SUBJECT: PROCUREMENT NO. 012026-1014
WEST SITCUM 11TH ST. IMPROVEMENTS

ADDENDUM NUMBER 03

WEST SITCUM TERMINAL 11TH STREET IMPROVEMENTS PROJECT ID NO. 201218.01 PURCHASE AGREEMENT # PA000000123

6724
G1.0
SH #1 OF #15

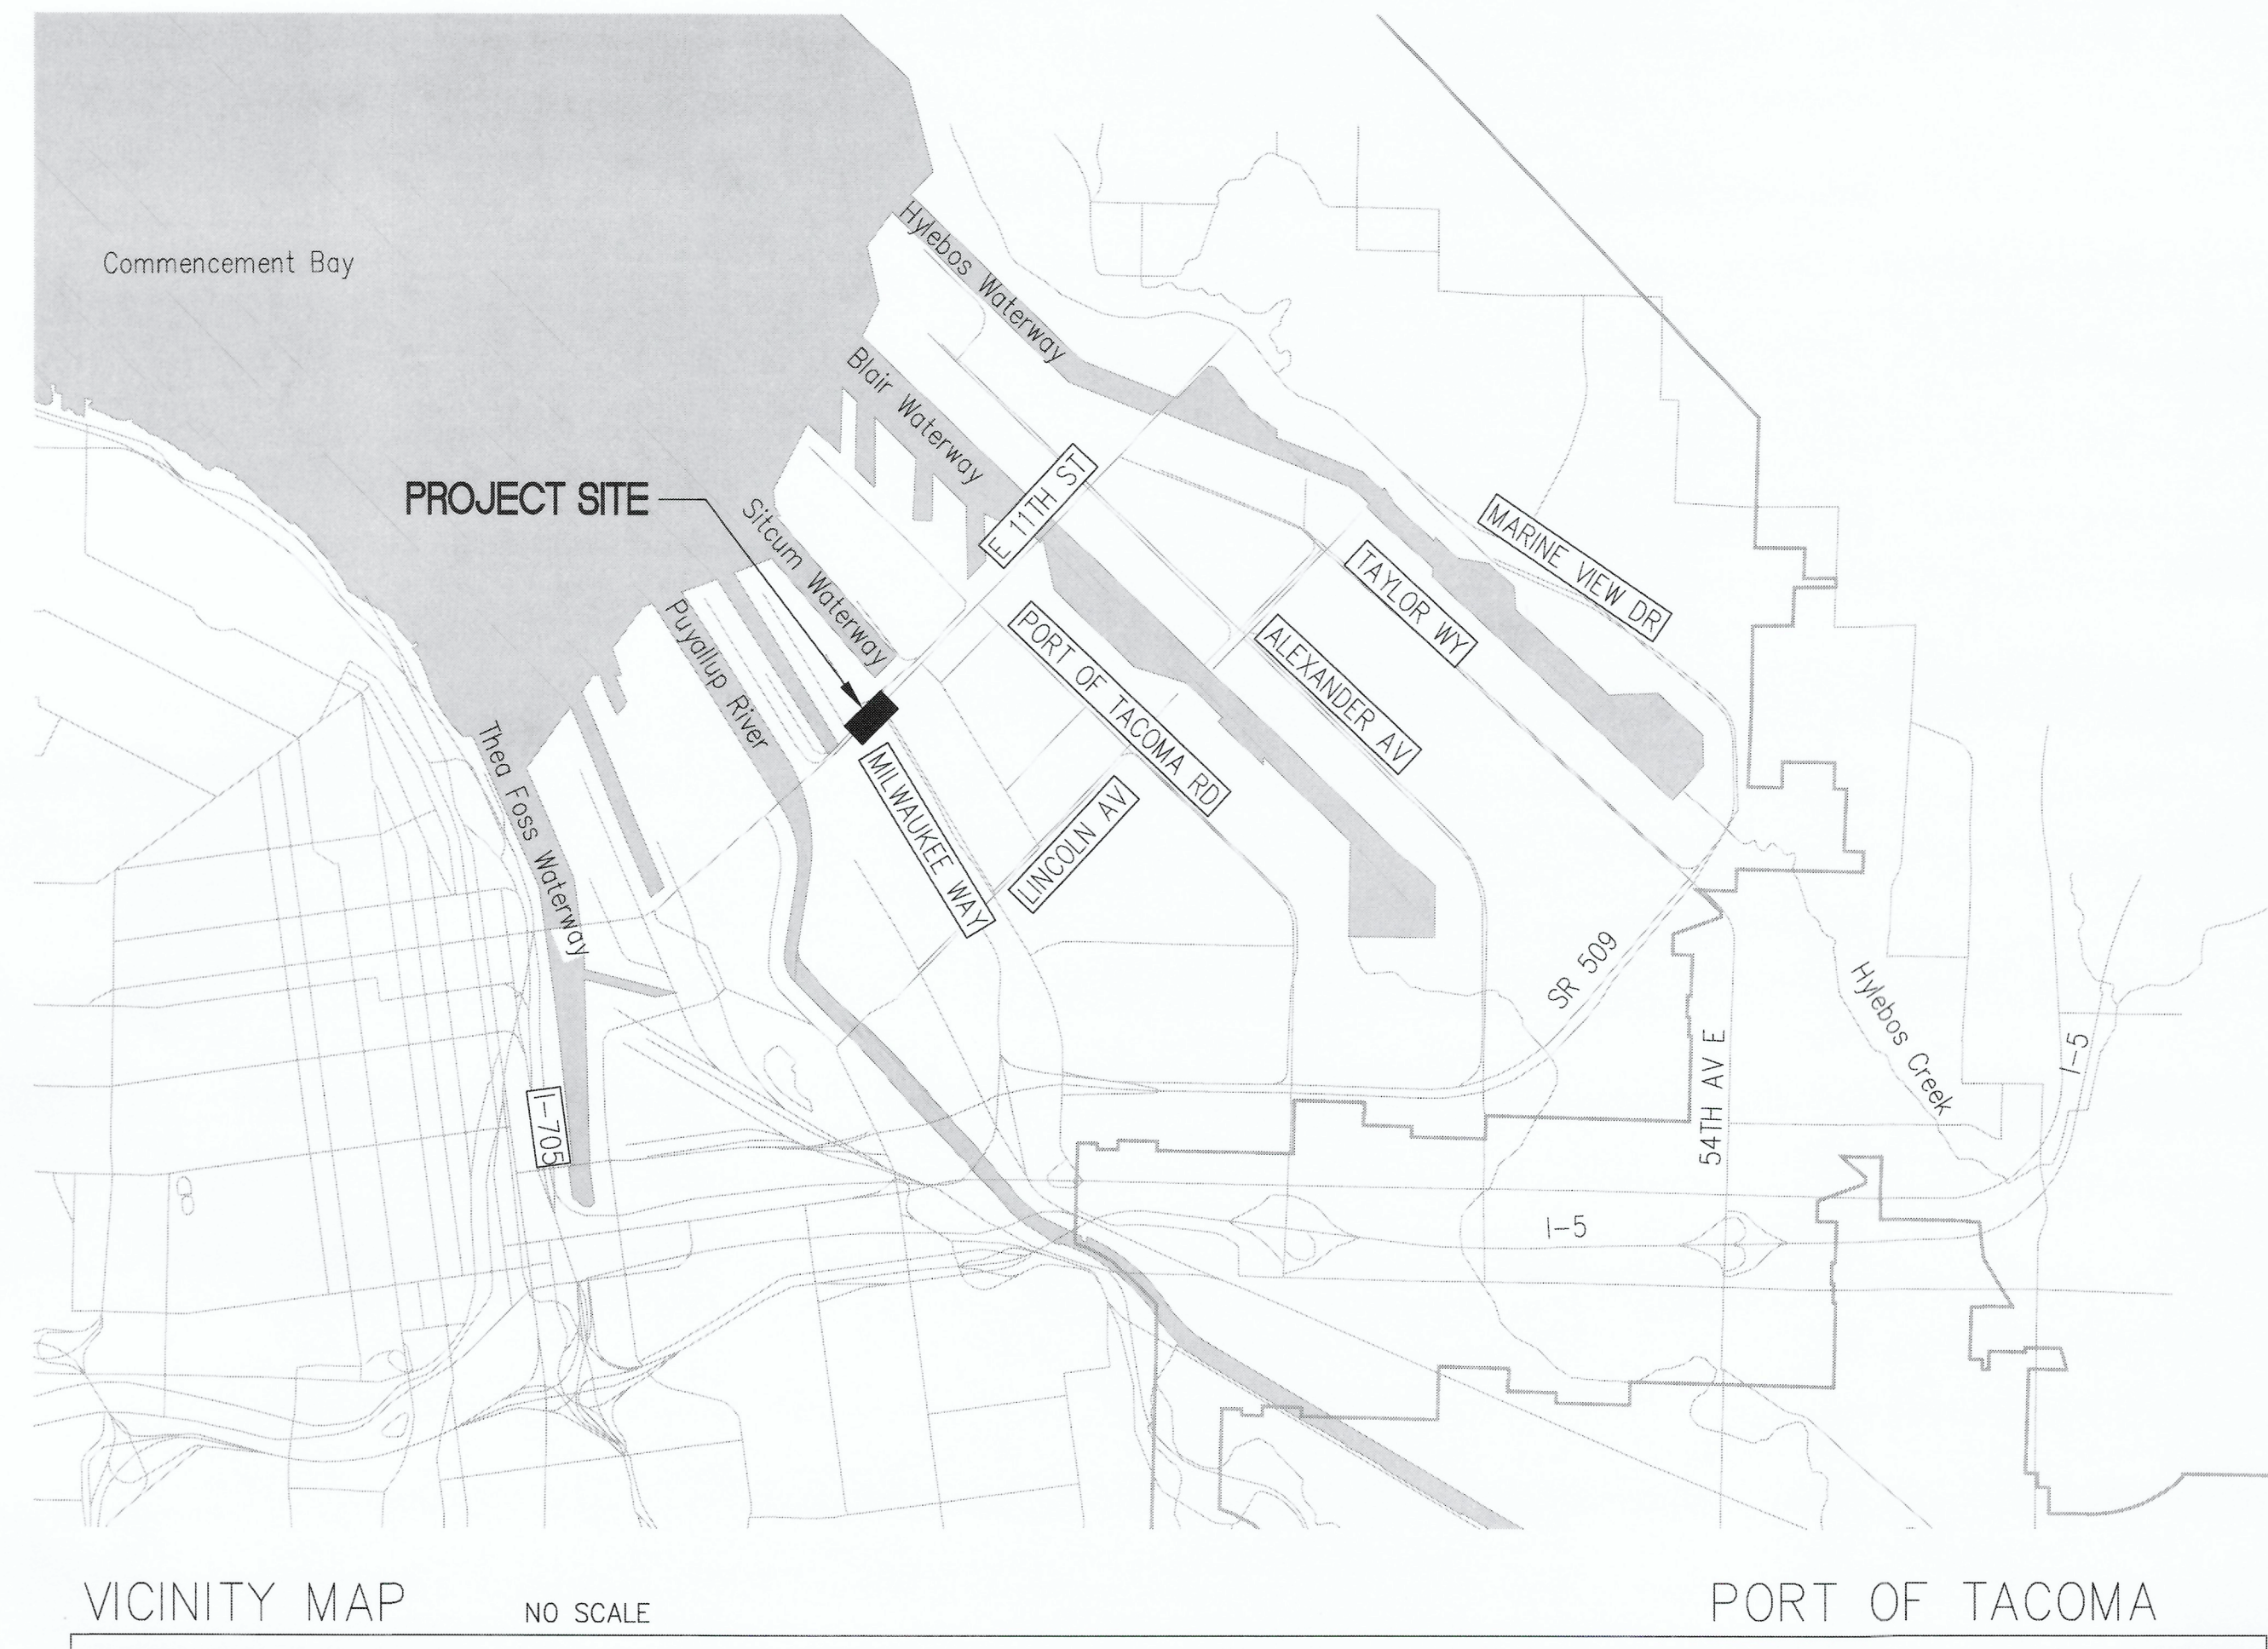
- Revised sheet title of G1.0, from 'Cover Sheet' to 'Title Sheet.
- Revised sheet title of C2.1, from 'Demolition and TESC Notes and Details' to 'Grading & Drainage Notes and Details'

Port of Tacoma logo and title block containing project information: 6724 C1.1 SH # OF #15, 11TH STREET IMPROVEMENTS (SITE SURFACING NOTES AND DETAILS), TOWNSHIP: 21, RANGE: 03, SECTION: 34, DATE: 05.29.26, PROJECT: 201218.01, PHASE: BID, and various approval and revision stamps.

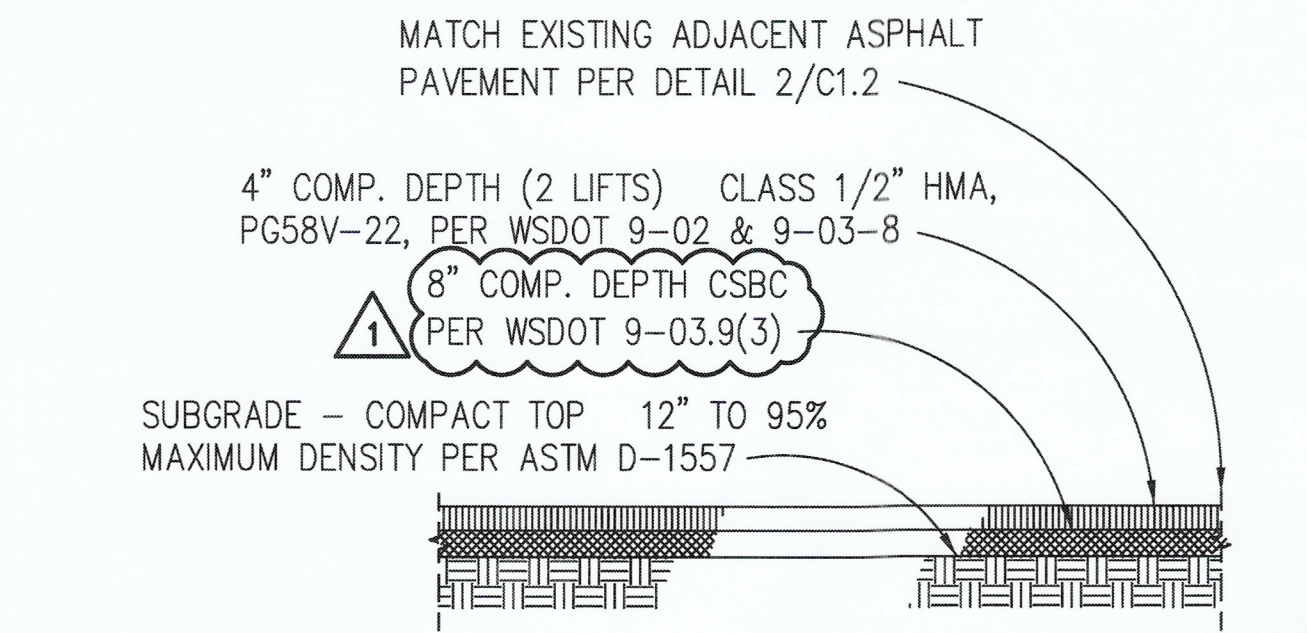
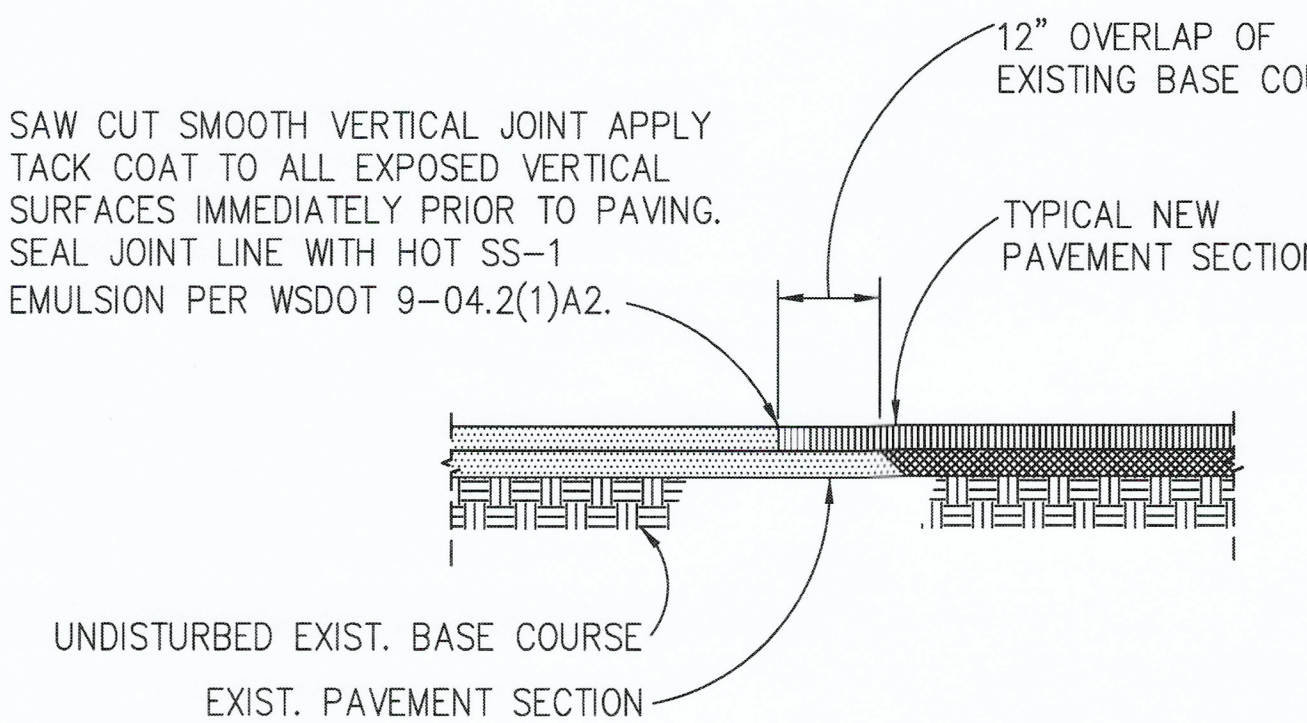
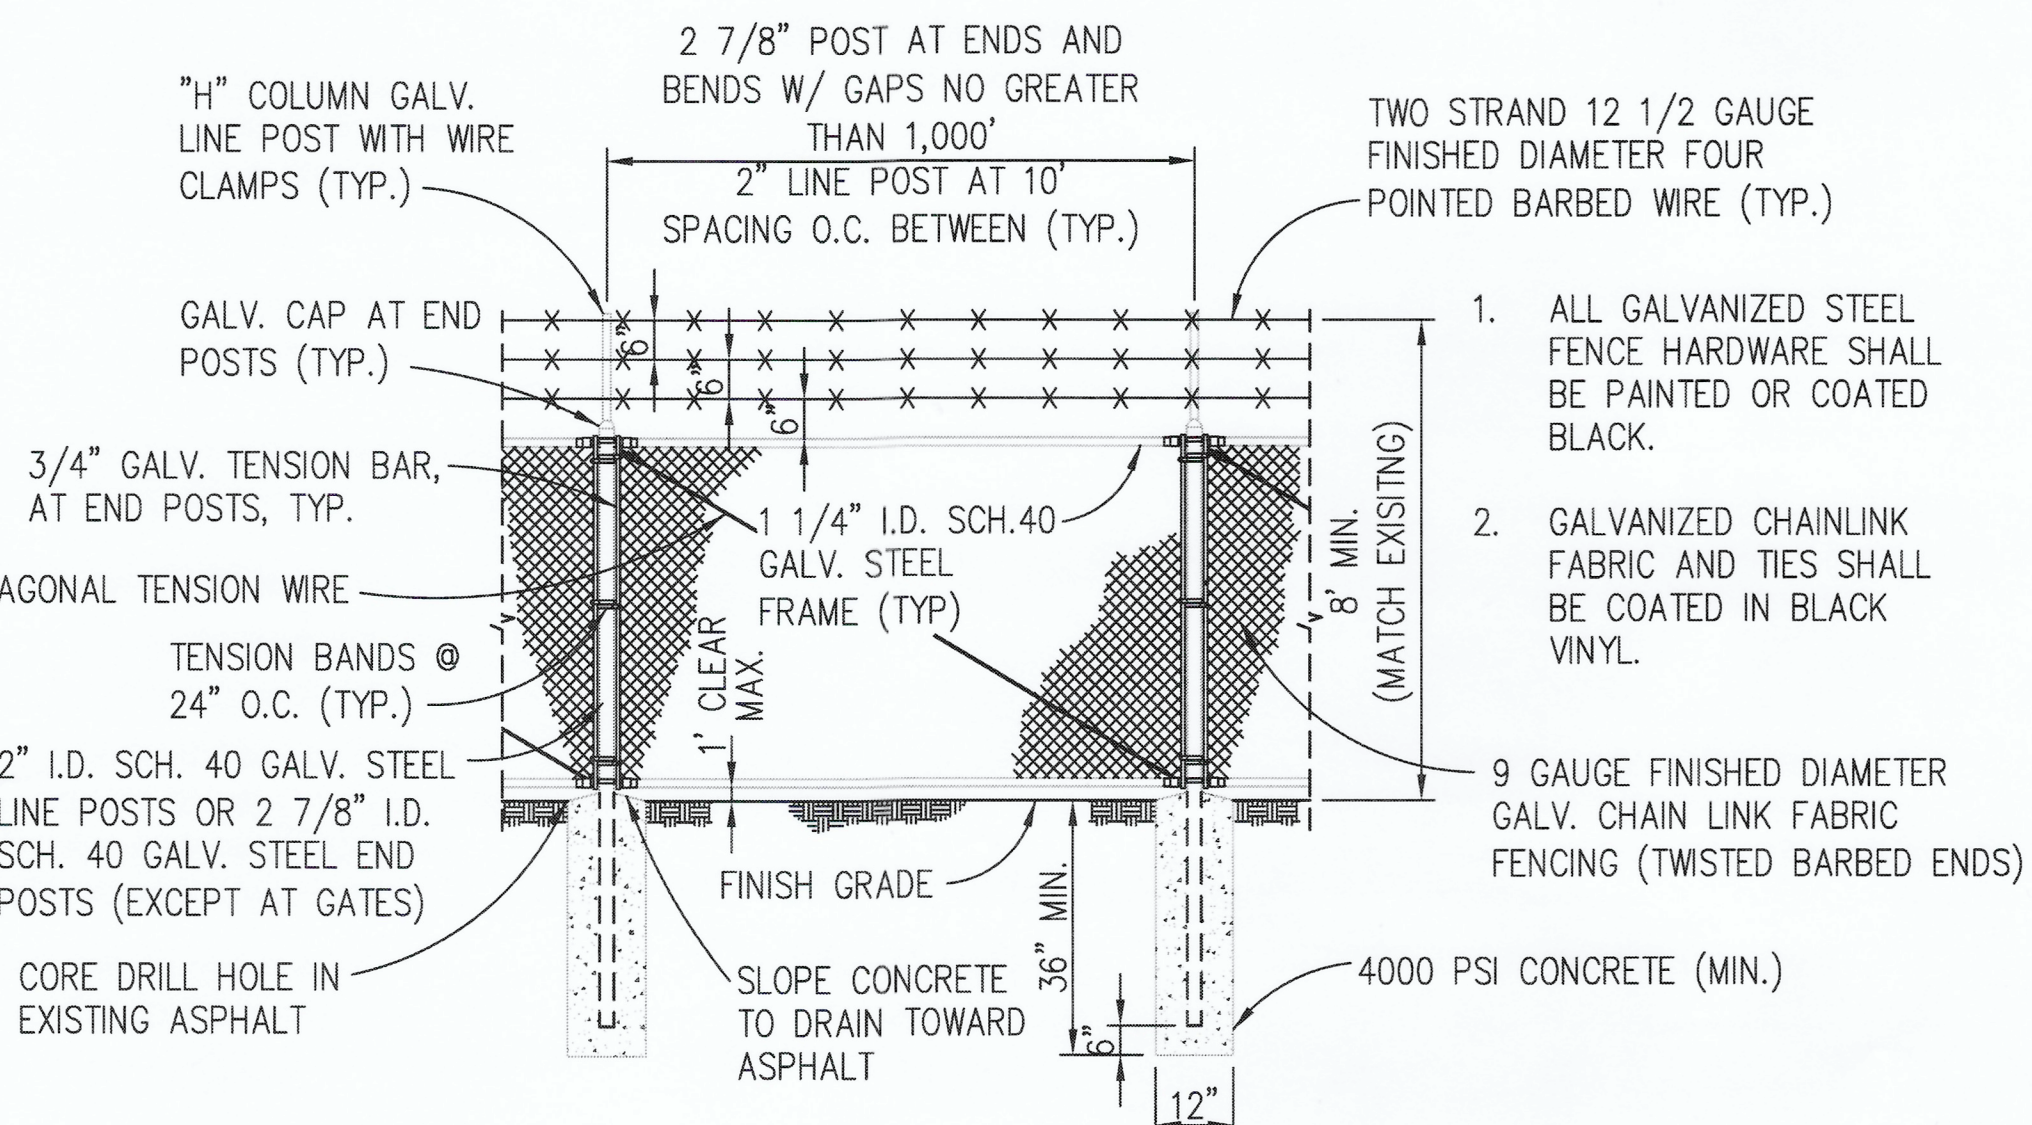
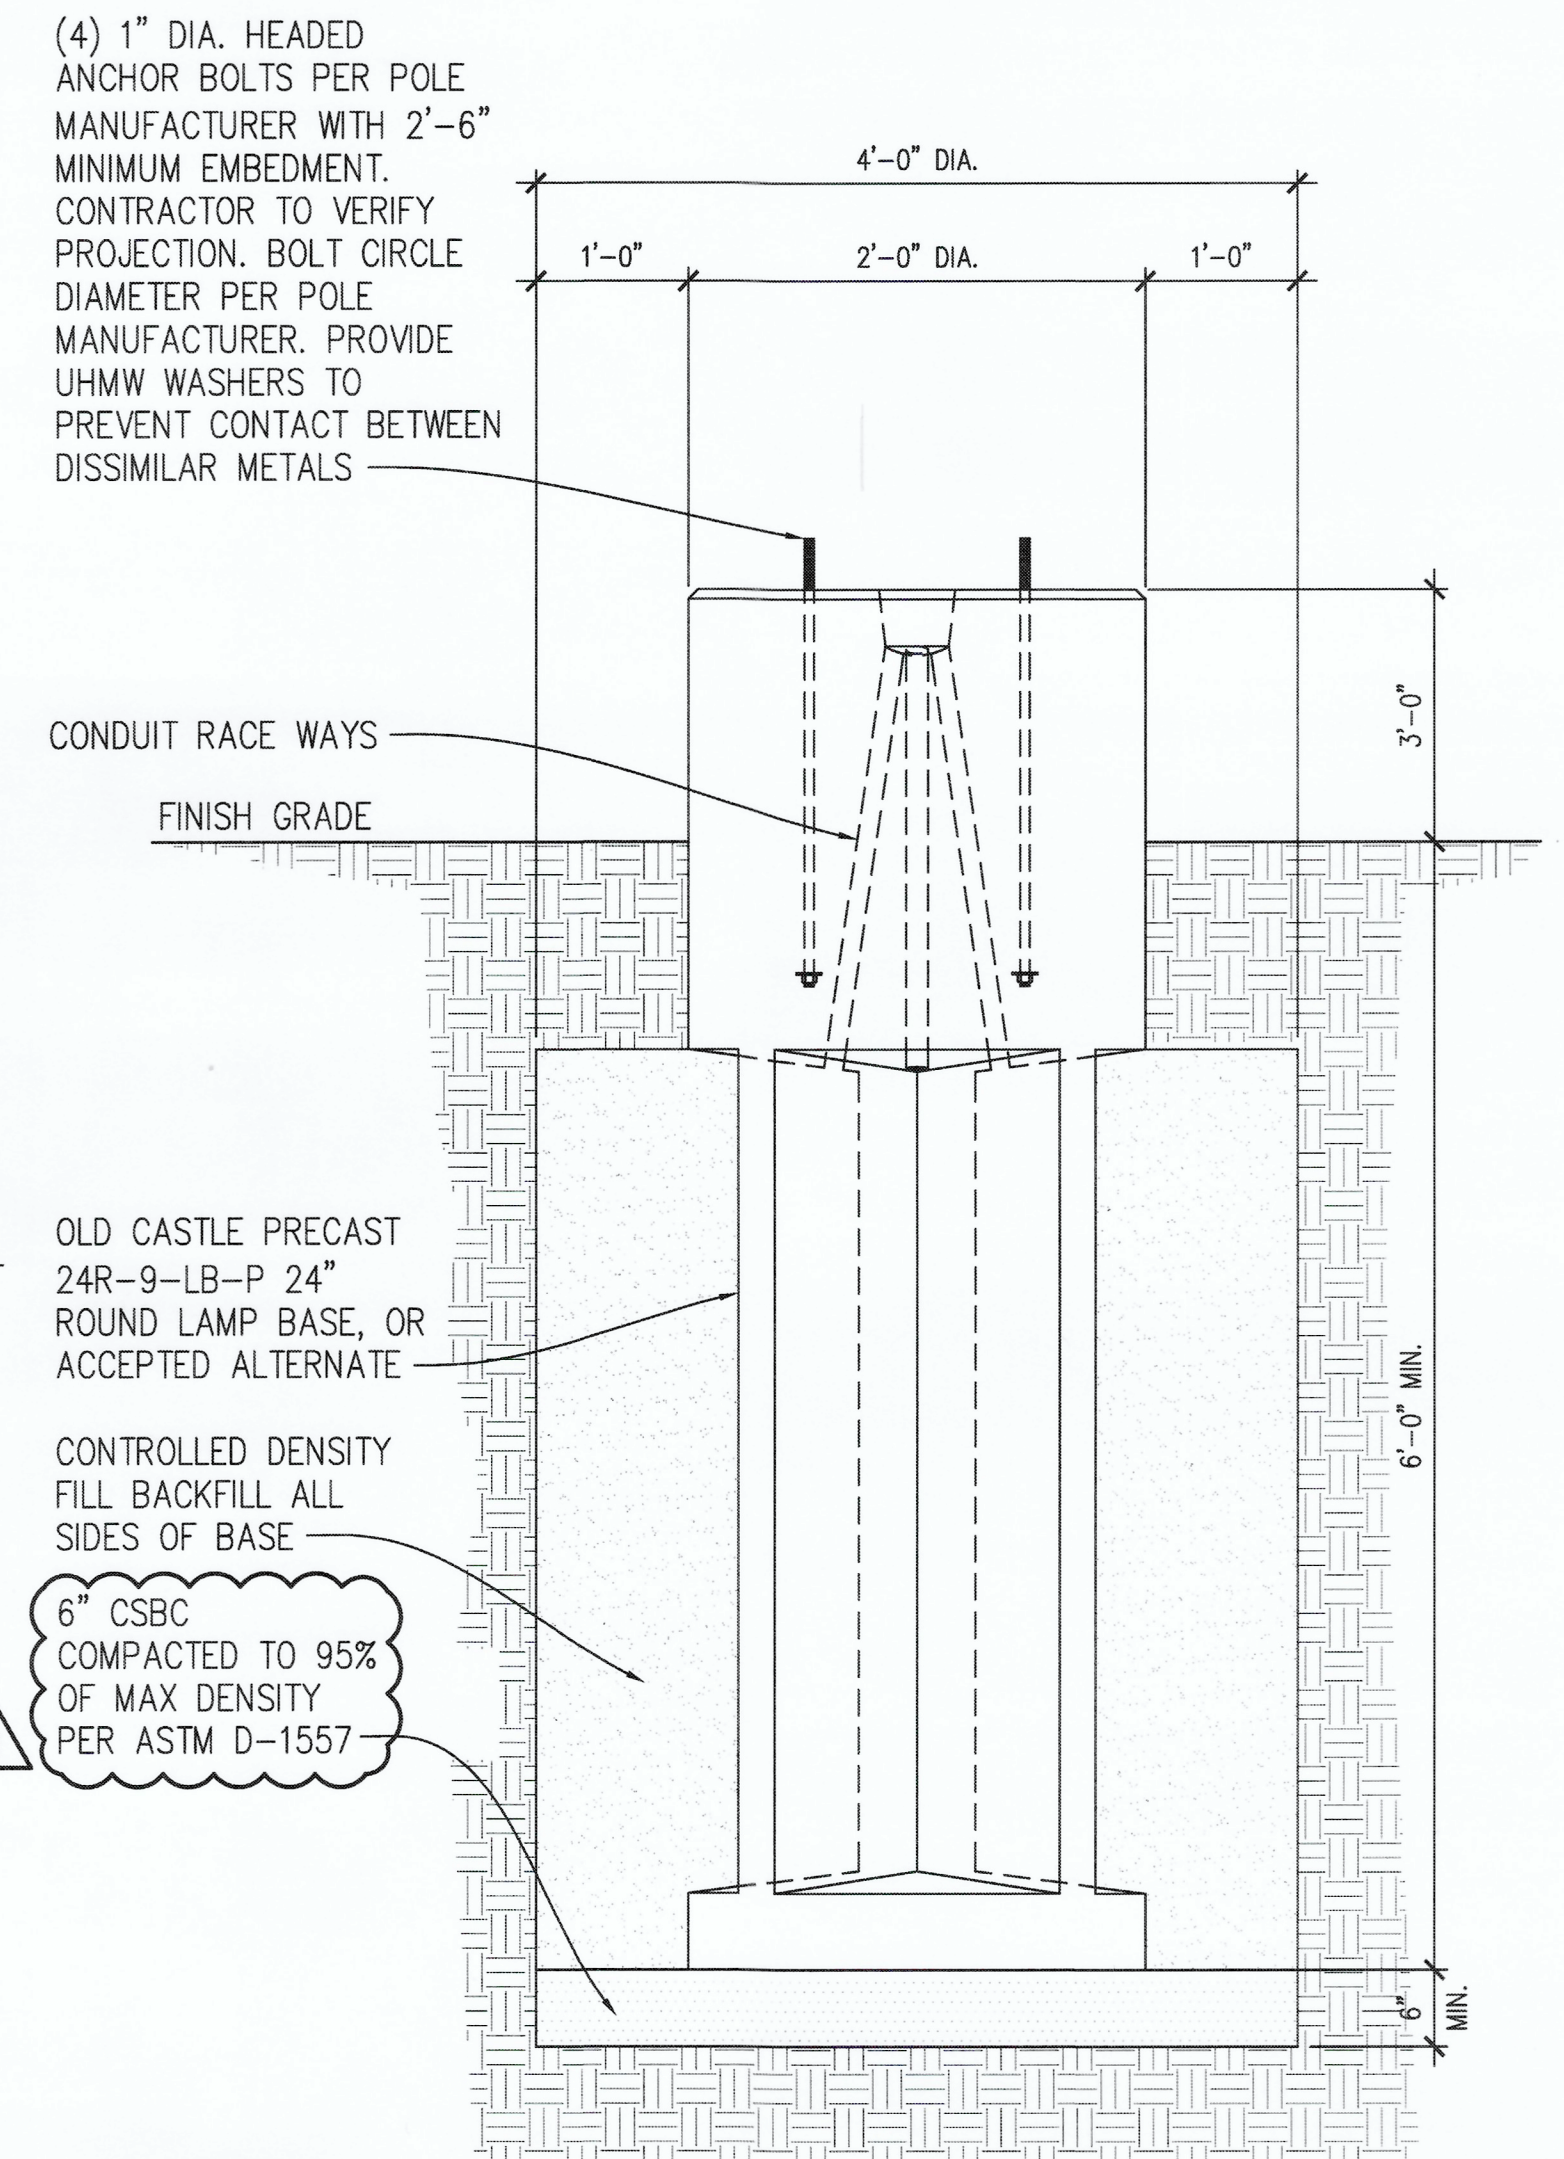
- Revised sheet title of C1.1, from 'Demolition and TESC Notes and Details' to 'Site Surfacing Notes and Details'.
- Replaced references for 'CSTC' with 'CSBC'.
